TITLE: RZN18-0006/ORD 1868-Request to rezone 3.0 acres of vacant land from RM-48 Medium Density Multi-Unit Residential to PR Planned Residential at 1435 Toms Creek Road (Tax Parcel No. 195-A 18) for the development of a multi-family student housing development by Kirk Johnson of Graystone Properties, LLC (applicant/contract purchaser) and Thomas D (III) Frith, J. Patrick Frith and Eric Frith (property owners).

DATE: August 3, 2018

SUBJECT: Frith Property (The View) – Revised Transportation Comments

Entrance and Toms Creek Crosswalks

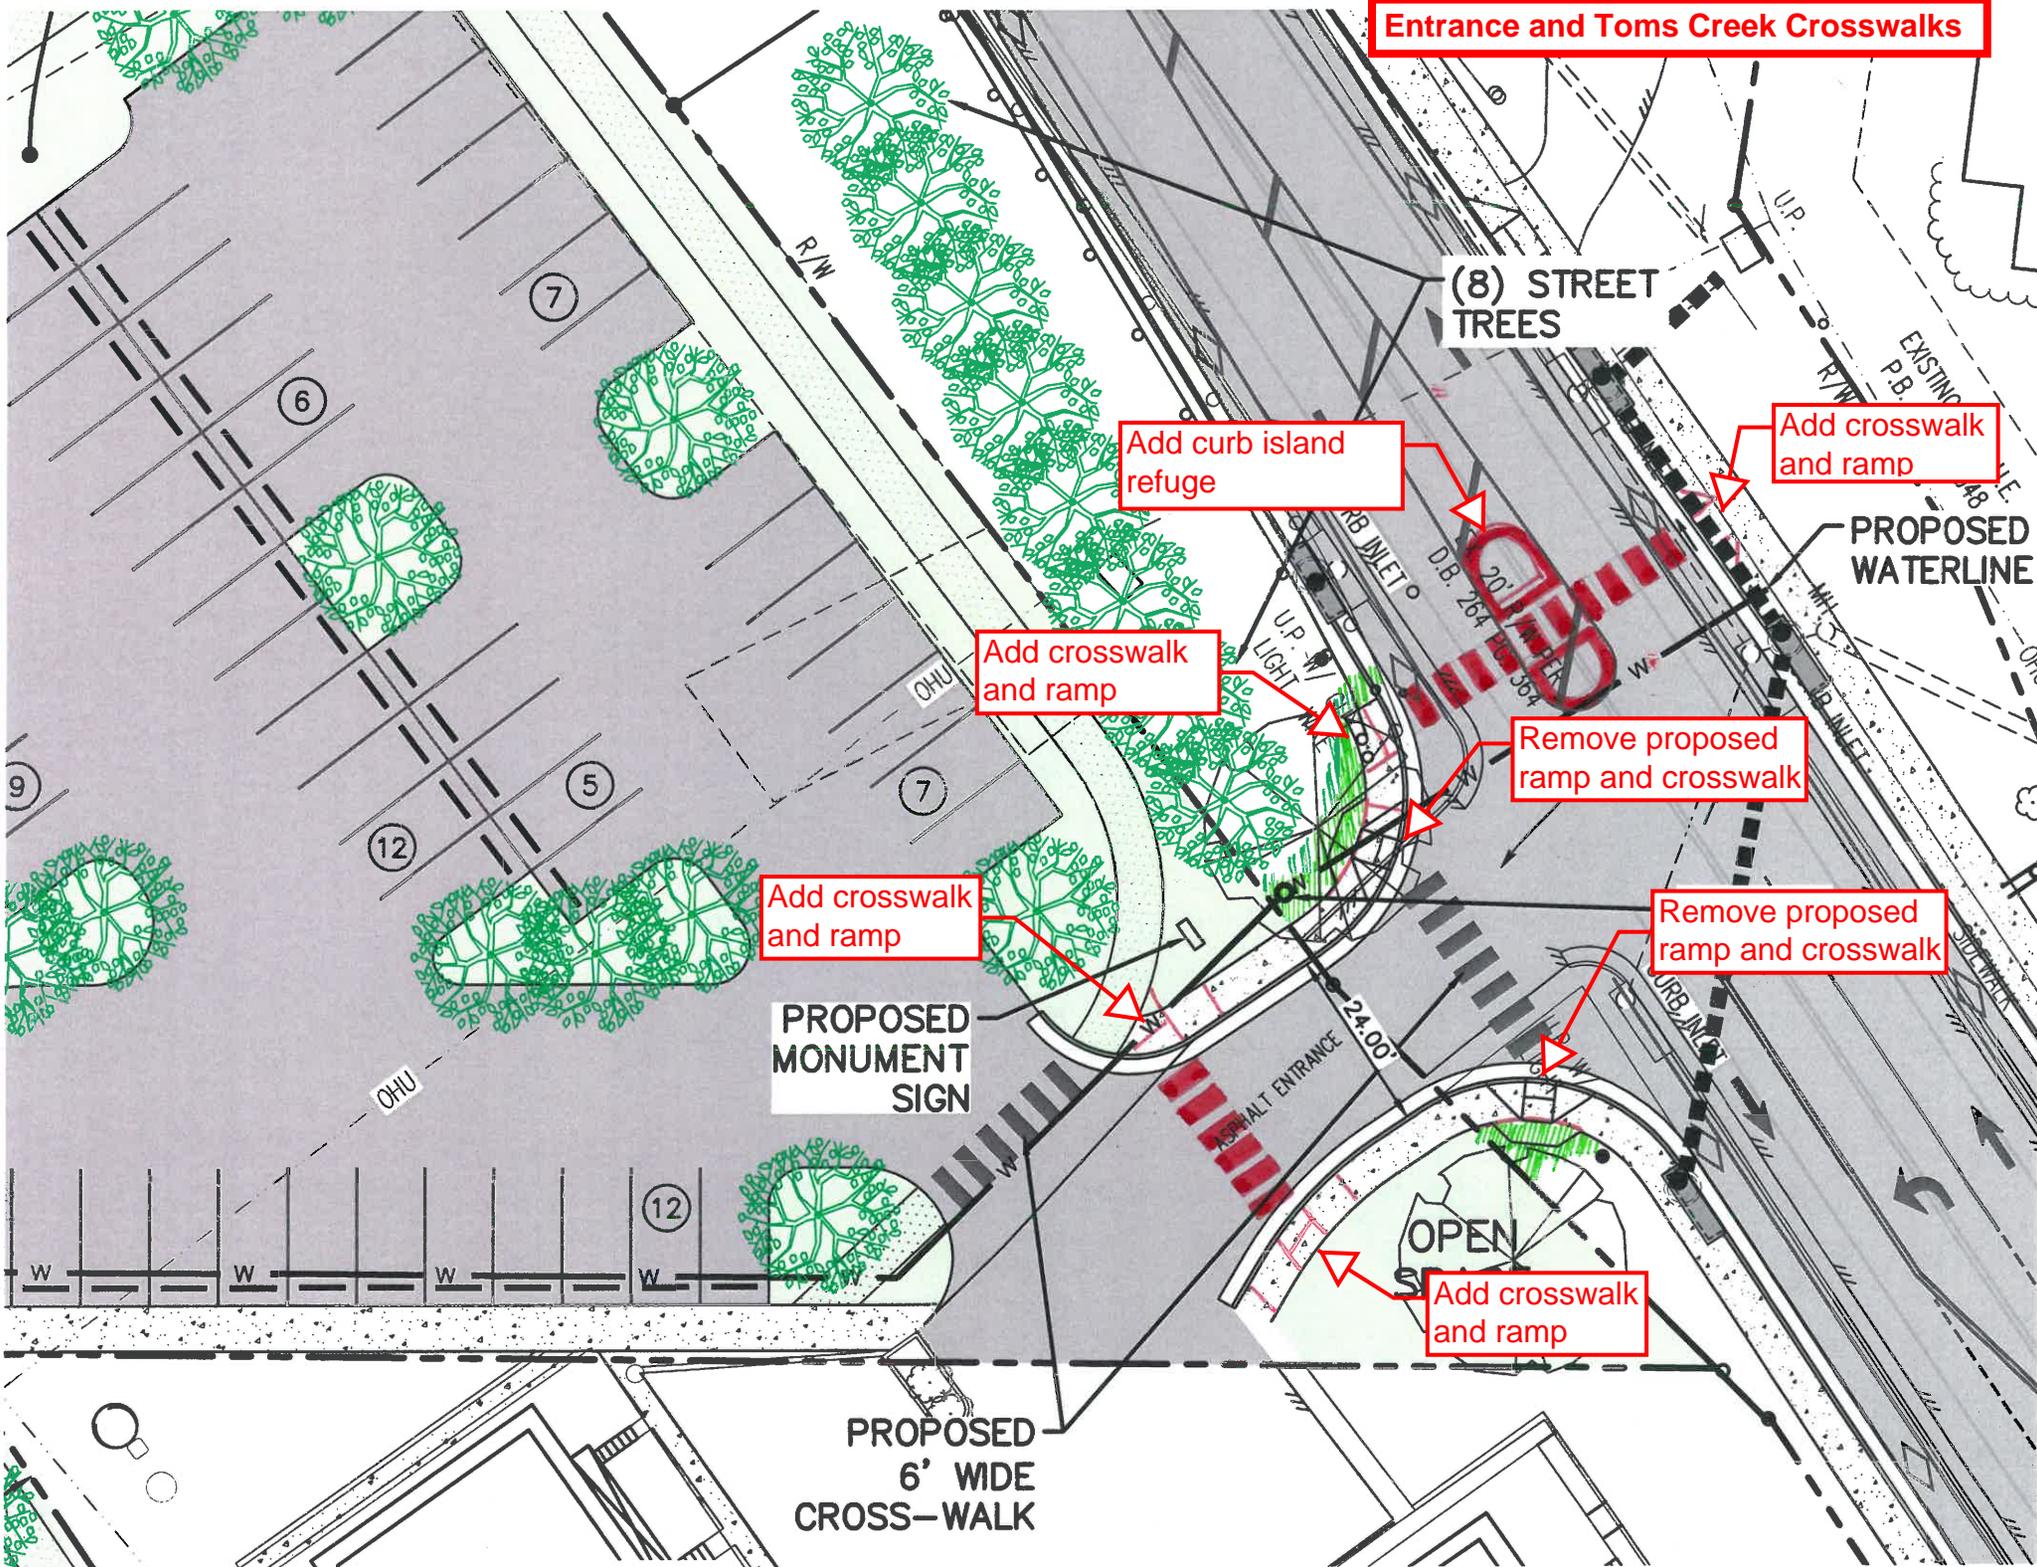
- Sidewalk extension along the western side of the existing drive aisle; curb ramp and crosswalk crossing the entrance drive aisle.
 - *In further discussion with Town engineering staff, it may be more preferable for the crosswalk to cross the drive aisle where the parking splits between the proposed and the existing developments, rather than at Toms Creek Road. Functionally, pedestrians coming from either the building or the northernmost parking area are more likely to cross the drive aisle closer to the throat of the entrance rather than at the mouth of the entrance at Toms Creek Road, as it is the shortest and most direct path, as well as being less steep. A sidewalk and crosswalk at the entrance on Toms Creek Road would not connect to anything further north of the project on Toms Creek Road, as there is no*

sidewalk on this side of the street over the Toms Creek Road Bridge. Placement of the crosswalk further in the throat of the entrance will also eliminate conflicts between the crosswalk and vehicles stopped exiting the development. Please see the sketch provided by staff showing mark-ups attached to this memo.

- *A crosswalk across Toms Creek Road both north of the development entrance and south of Sunridge Drive may be desirable. Crosswalks in these locations would facilitate pedestrians traveling northbound on Toms Creek Road across the bridge, and facilitate bicycles using the Givens Lane Trail southbound into town. The application already shows sidewalk extended along the north side of the entrance to Toms Creek Road, terminating at the existing guard rail. A curb ramp is shown to cross the mouth of the entrance. This curb ramp should be modified to provide passage only across Toms Creek Road, and not across the entrance. The painted shifting taper should be modified to be a curb island refuge area for the crosswalk. A curb ramp should be installed on the opposite side of Toms Creek Road in the new sidewalk to accept the crosswalk. To facilitate southbound bicycle traffic from the Givens Lane Trail, bicycles traveling toward town could exit the trail, and cross Toms Creek Road to the southbound bike lane, or ride on the 8' sidewalk on the east side of Toms Creek Road to Sunridge Drive, dismount, and walk across Sunridge Drive. From there, cyclists could walk across Toms Creek Road to access the southbound bike lane on Toms Creek Road into town. If this improvement is to be made, the applicant should construct the necessary curb ramp improvements to the sidewalk. Curb ramps would need to be provided at the crosswalk across Sunridge Drive, and at the crossing location on Toms Creek Road sidewalk. Furthermore, what is shown as a painted shifting taper should be constructed as a curb island with refuge area for the crosswalk across Toms Creek Road. Please see the sketch provided by staff showing mark-ups attached to this memo.*

Add curb island refuge

Add crosswalk and ramp

Add crosswalk and ramp

Remove proposed ramp and crosswalk

Add crosswalk and ramp

Remove proposed ramp and crosswalk

OPEN
Add crosswalk and ramp
